ORIGINATION FORM

Proposed Revisions to a Standard Plans Index
(Please provide all information — Incomplete forms will be returned)

Index Number: 711-003
Sheet Number (s): 5 and 6
Index Title: Interchange Markings

INTERCHANGE MARKINGS

INDEX	SHEET
711-003	5 of 8

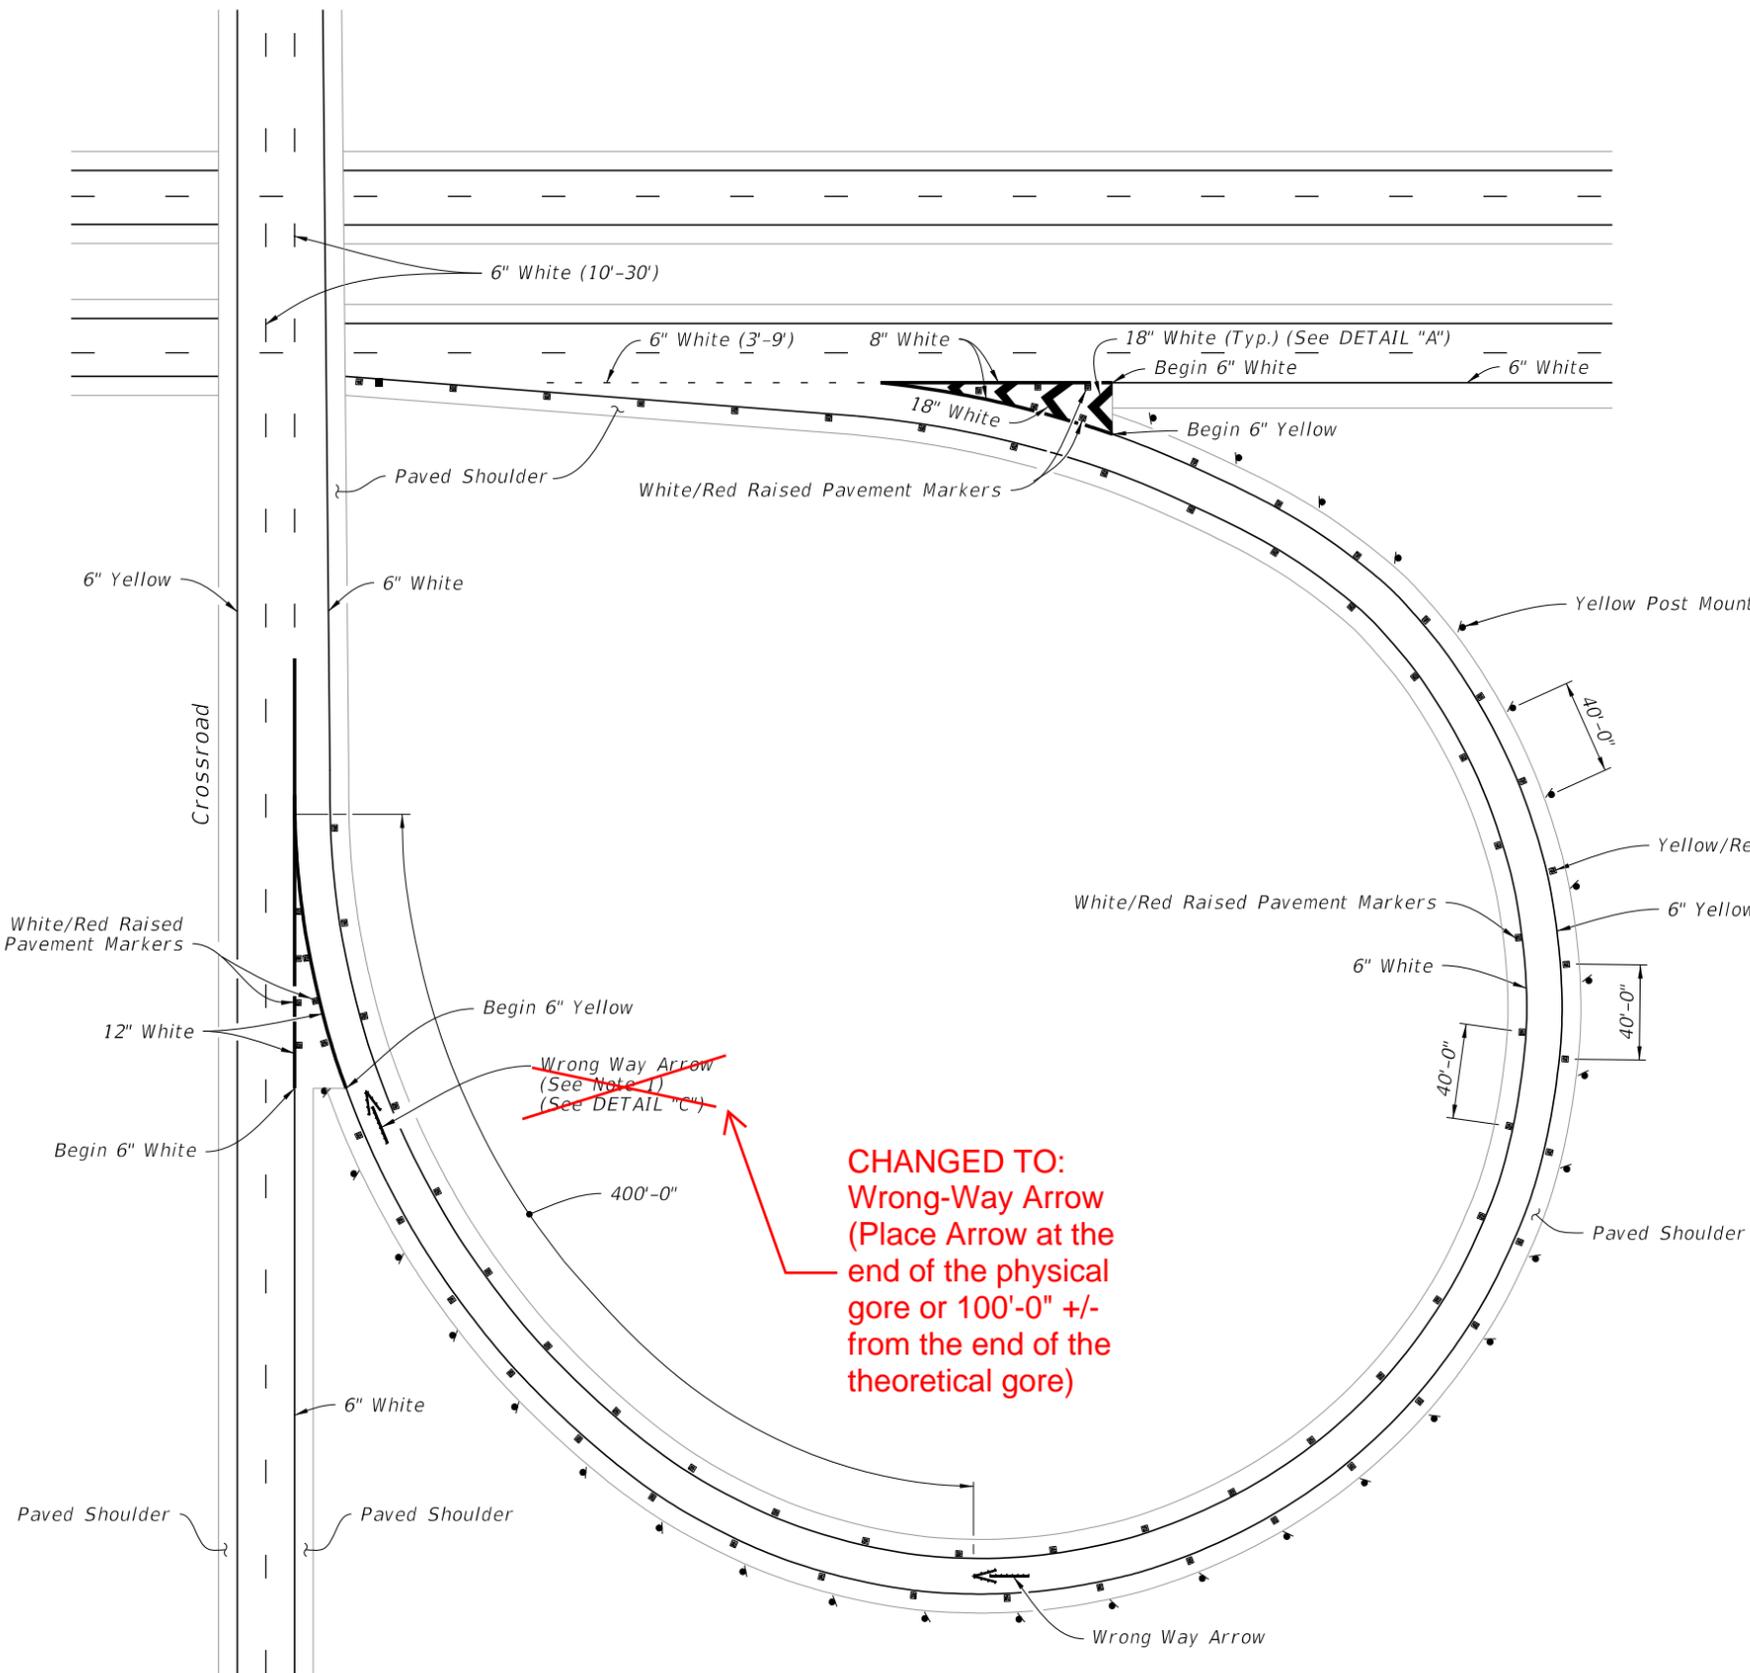
Sheet 5: Deleted Detail "C" from sheet 5 as it is now located on sheet 3 of Index 706-001; Moved Note 1 to the Wrong-Way Arrow callout at the Gore; Deleted Note 2; Deleted the "See Note 3" reference from the Yellow Post Mounted Delineator callout.

CHANGED TO:
 Wrong-Way Arrow
 (Place Arrow at the
 end of the physical
 gore or 100'-0" +/-
 from the end of the
 theoretical gore)

- ~~1. Place the Wrong Way Arrow at the gore.~~
- 2. Post delineators spaced at 40' on curves of the entrance and exit of ramps. The spacing on the tangent portion of the ramp section is 300'-0". All delineators are to be setback 4' from shoulder break. Post delineators should not be discontinued in sections with guardrail.

~~TYPICAL CURVED EXIT RAMP AND WRONG WAY ARROW~~

INDEX	SHEET
711-003	6 of 8

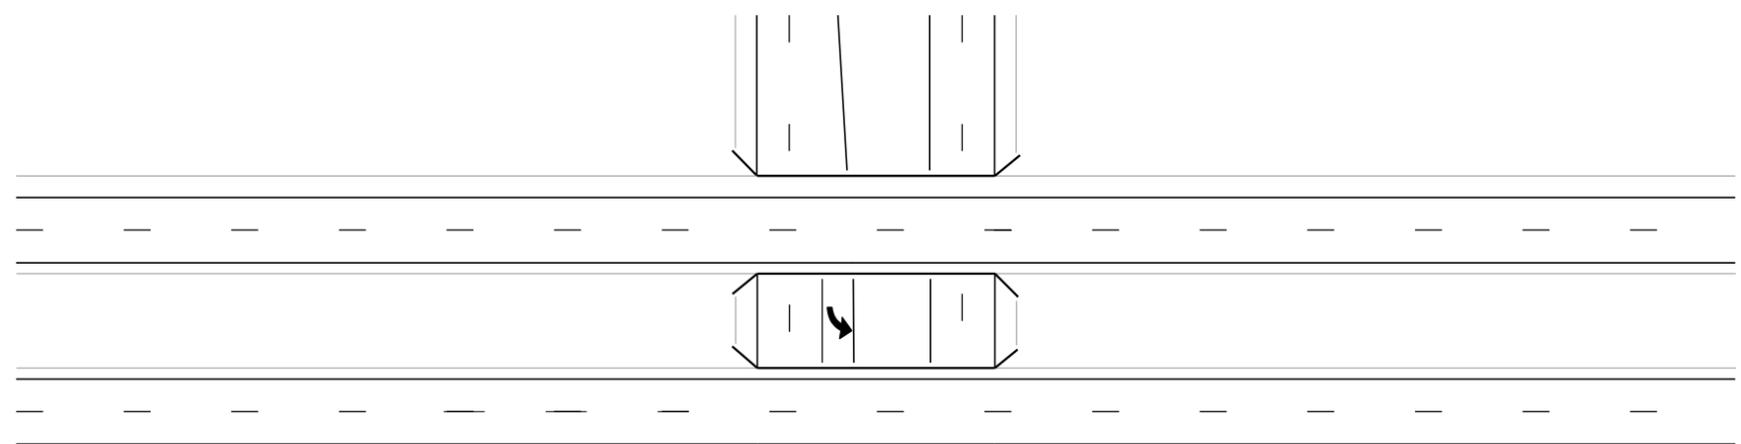
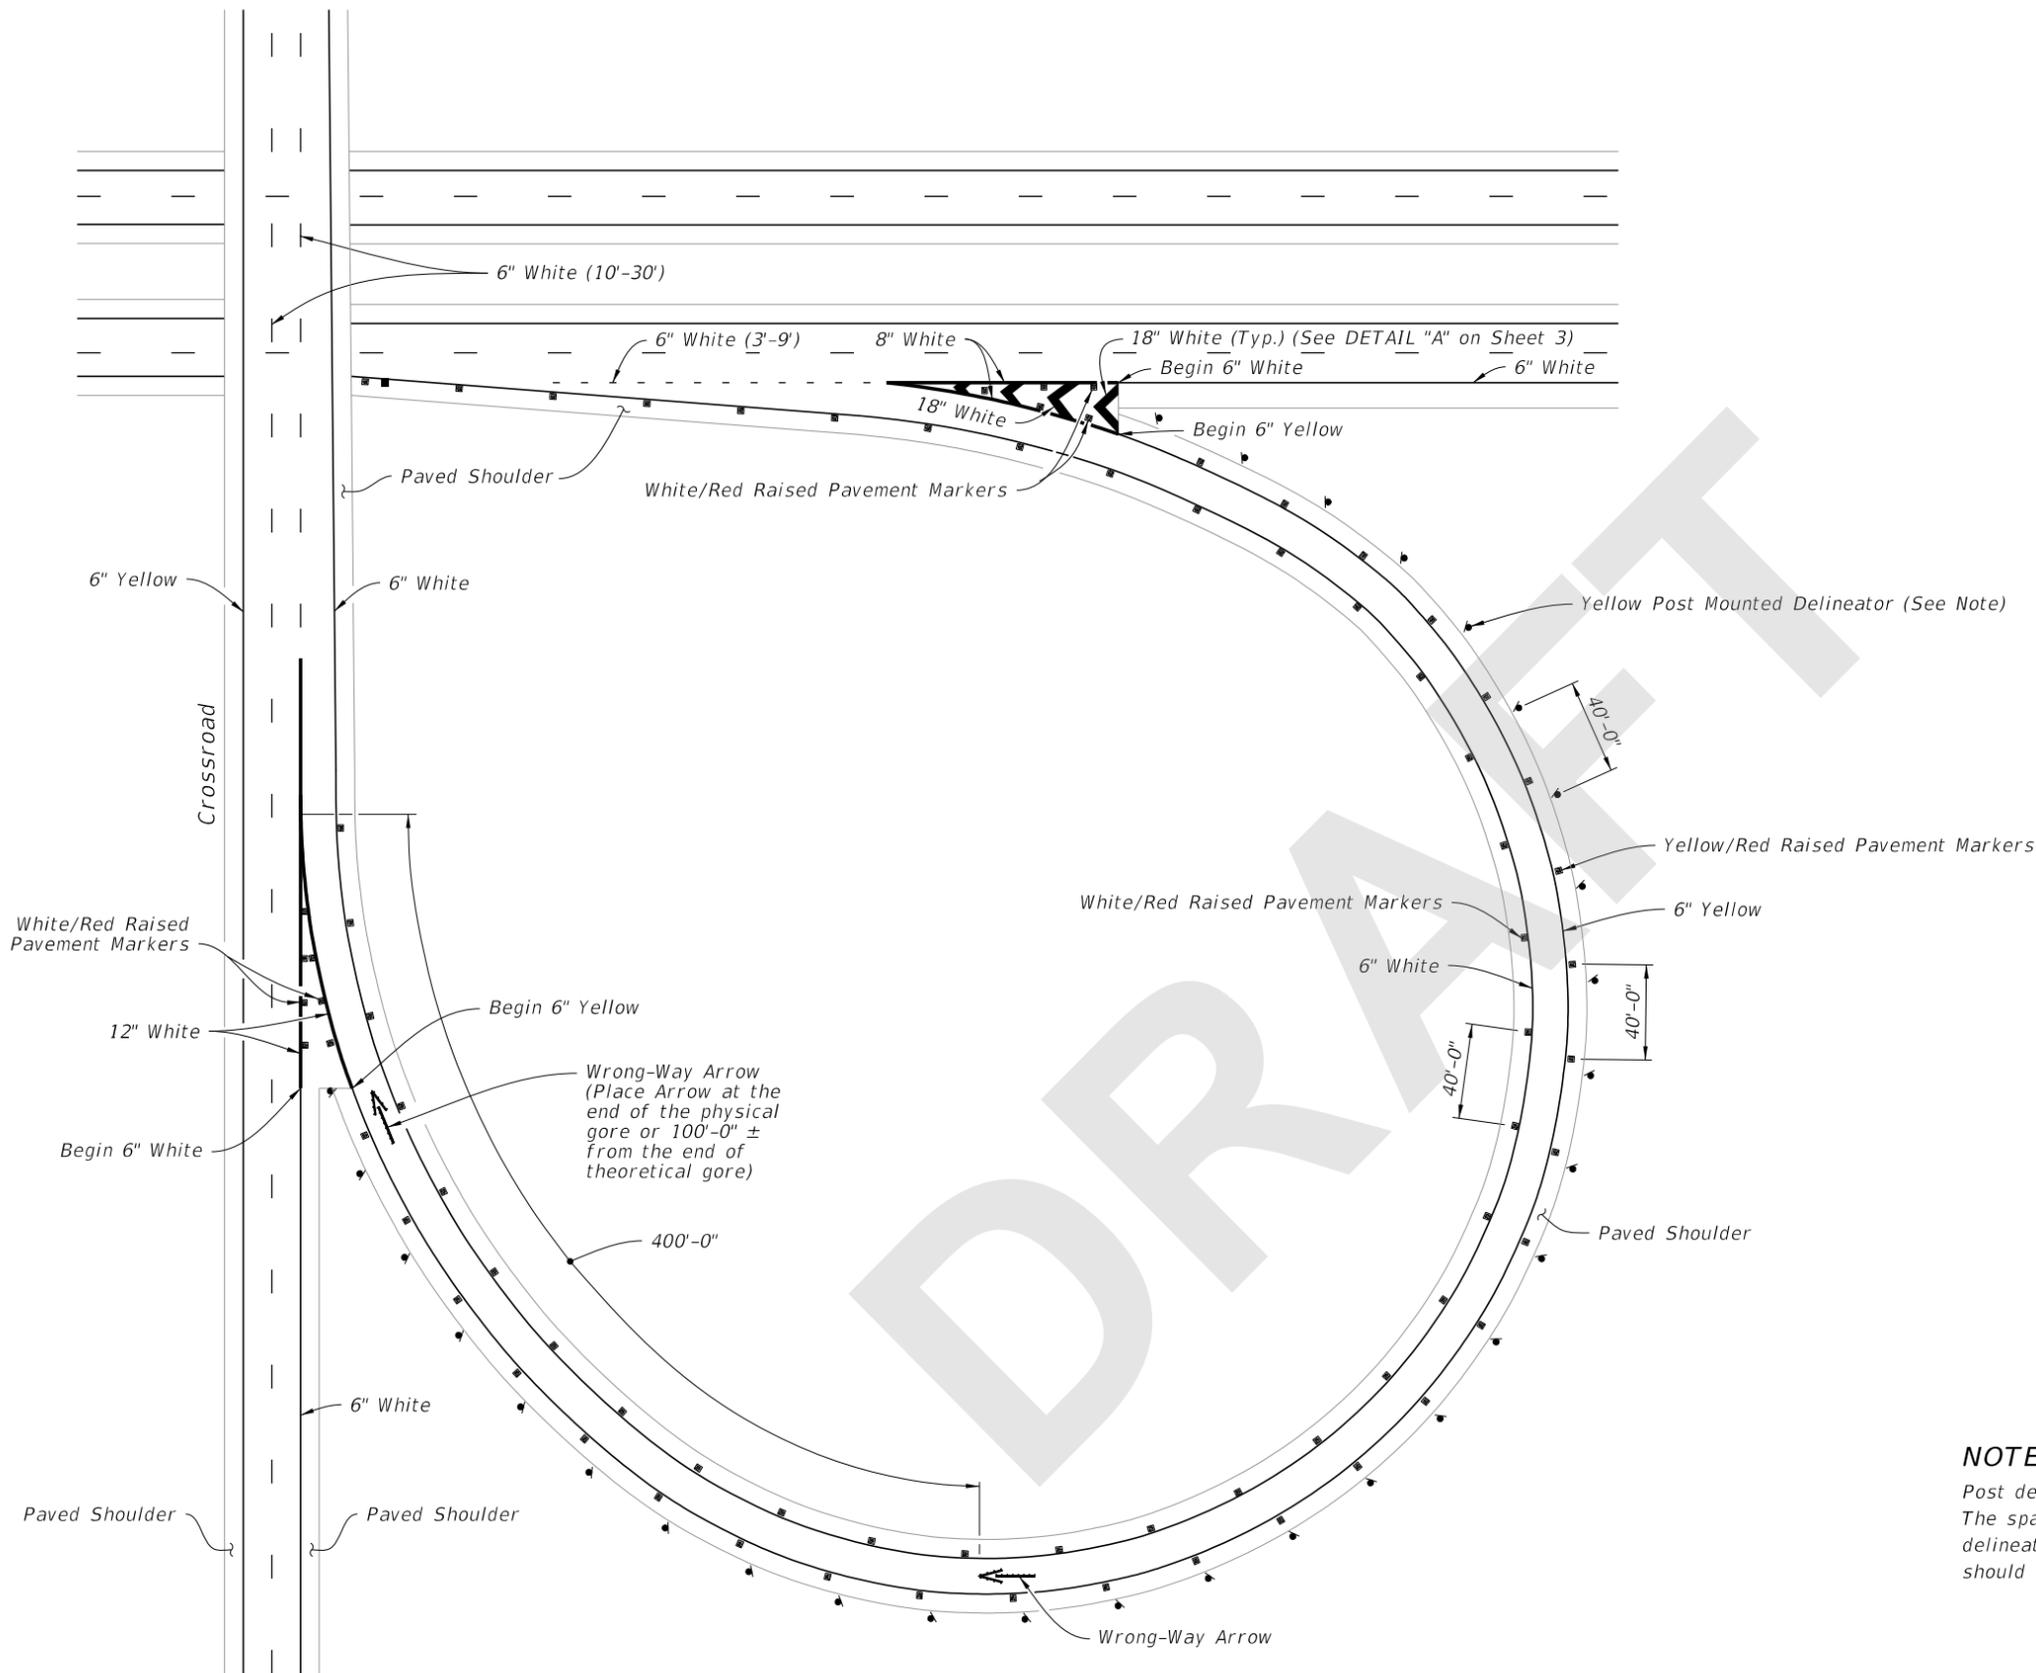
Sheet 6: Moved Note 1 to the Wrong-Way Arrow callout at the Gore; Deleted the note reference and the Detail"C" reference for the Wrong-Way Arrow callout on the off ramp.

Wrong-Way Arrow

~~Wrong-Way Arrow (See Note 1)
(See DETAIL "C", Sheet 5)~~

CHANGED TO:
Wrong-Way Arrow
(Place Arrow at the end of the physical gore or 100'-0" +/- from the end of the theoretical gore)

~~Wrong Way Arrow
(See Note 1)~~

- ~~1. Place the Wrong Way Arrow at the end of the physical gore or 100'-0" +/- from the end of theoretical gore.~~
- ~~2. Post delineators spaced at 40' on curves of the entrance and exit of ramps. The spacing on the tangent portion of the ramp section is 300'-0". All delineators are to be setback 4' from shoulder break. Post delineators should not be discontinued in sections with guardrail.~~

SHEET
 5 of 8

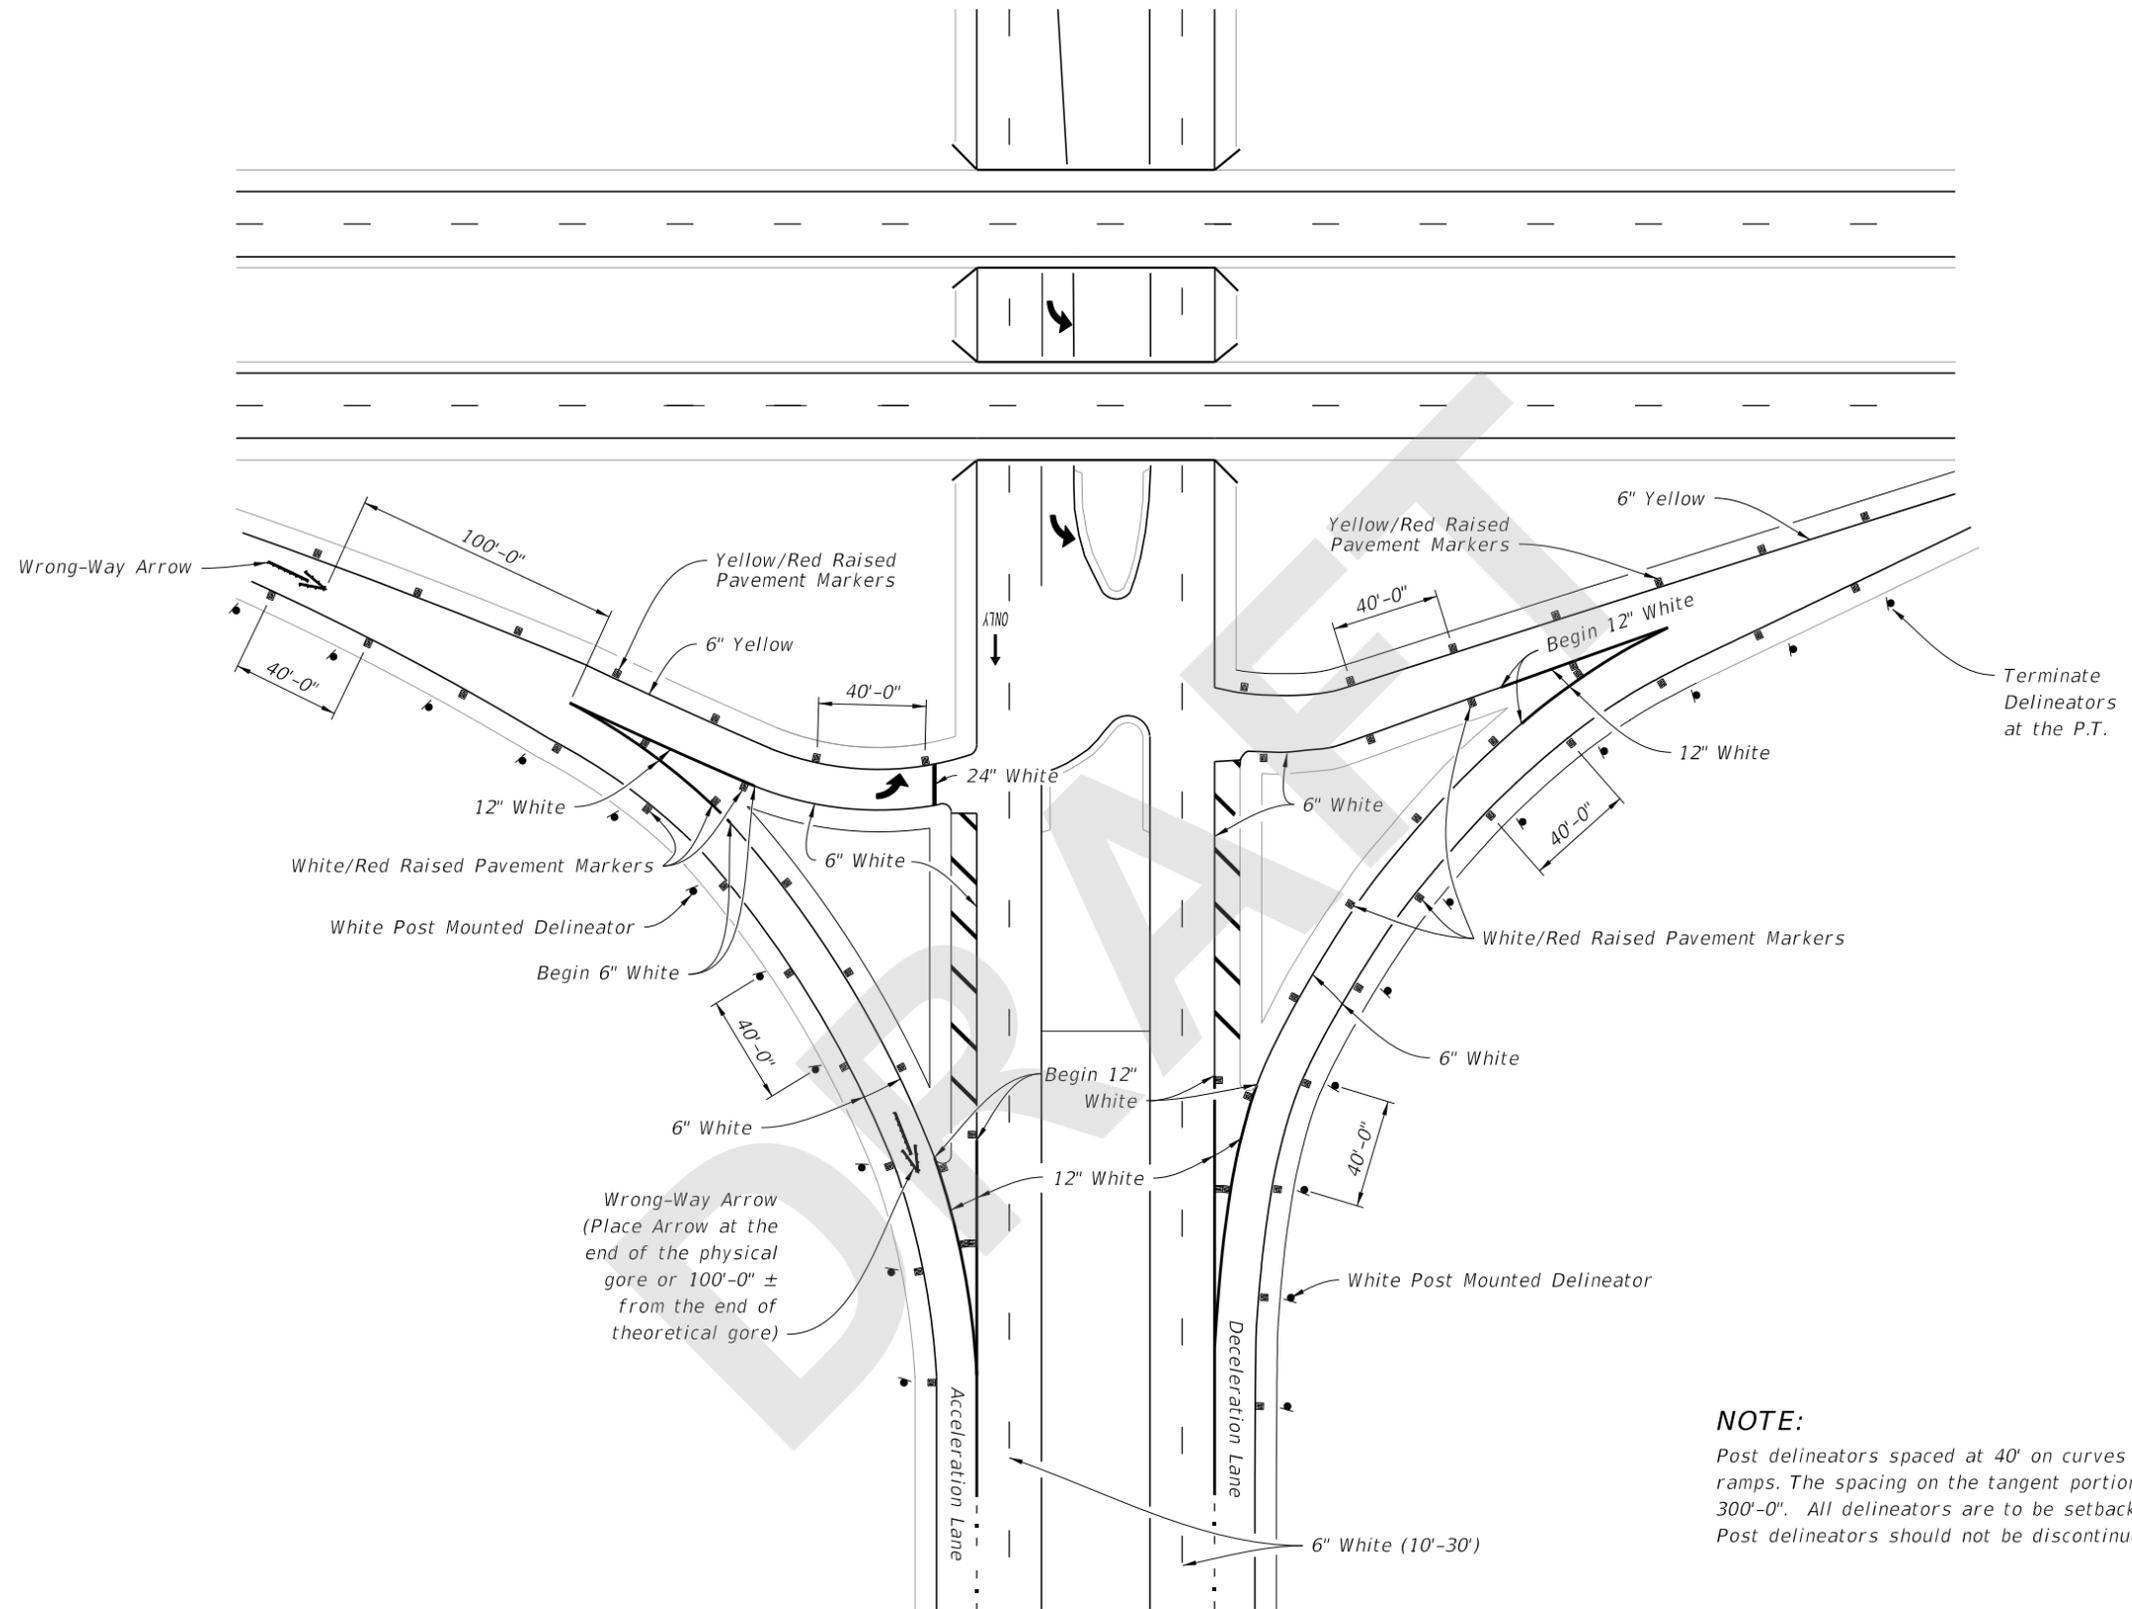
TYPICAL CURVED EXIT RAMP

NOTE:
 Post delineators spaced at 40' on curves of the entrance and exit of ramps. The spacing on the tangent portion of the ramp section is 300'-0". All delineators are to be setback 4' from shoulder break. Post delineators should not be discontinued in sections with guardrail.
